Access Compliance Report Public Rights-of-Way (Curb Ramps)

Main Street: GAIA_LN Cross Street: GAIA_LN Location: S

ADA ID: RPRK211028113753 Ramp Type: Type 4 - Parallel Initial Pass/Fail: Fail Overall Compliance: No Severity Score: 16

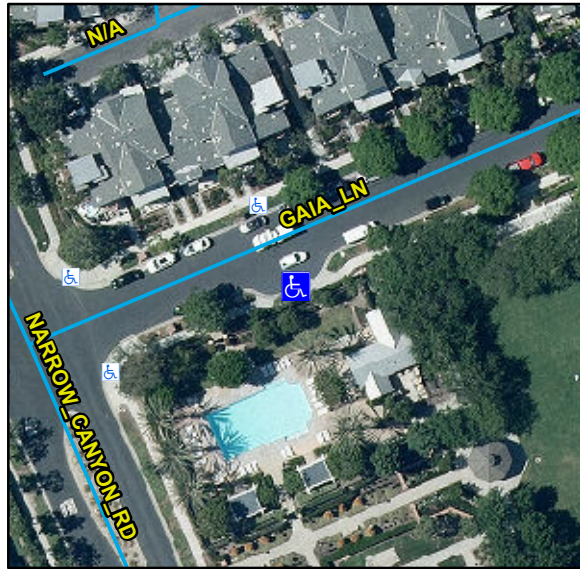
R204.3, R304.3.2, R304.5.3, STD 1115

Compliance	Description	Data	Compliance	Description	Data
N/A	Ramp Length LT (in)	97	N/A	Ramp Length RT (in)	97
Yes	Ramp Width LT (in)	52	Yes	Ramp Width RT (in)	52
No	Ramp Run Slope LT (%)	9.8	Yes	Ramp Run Slope RT (%)	4.7
No	Ramp Cross Slope LT (%)	3.2	Yes	Ramp Cross Slope RT (%)	1.6
N/A	Landing Present	N/A	N/A	DWS Provided	N/A
N/A	Landing Length (in)	N/A	N/A	DWS Contrast	N/A
N/A	Landing Width (in)	N/A	N/A	DWS Length (in)	N/A
N/A	Landing Run Slope (%)	N/A	N/A	DWS Full Width	N/A
N/A	Landing Cross Slope (%)	N/A		DWS Offset Type	N/A
N/A	Landing Movement Obstructed?	N/A	N/A	DWS Offset Left (in)	N/A
	Landing Movement Type	N/A	N/A	DWS Offset Right (in)	N/A
N/A	Landing Shared	N/A			
N/A	Clear Space	N/A			
N/A	Clear Space To Crosswalk (in)	N/A			
N/A	Marked Crosswalk 1	No	N/A	Marked Crosswalk 2	N/A
	Crossing 1 Direction	N		Crossing 2 Direction	N/A
	Marked Crosswalk 1 Width (in)	N/A		Marked Crosswalk 2 Width (in)	N/A

Remove & Replace Entire Ramp.
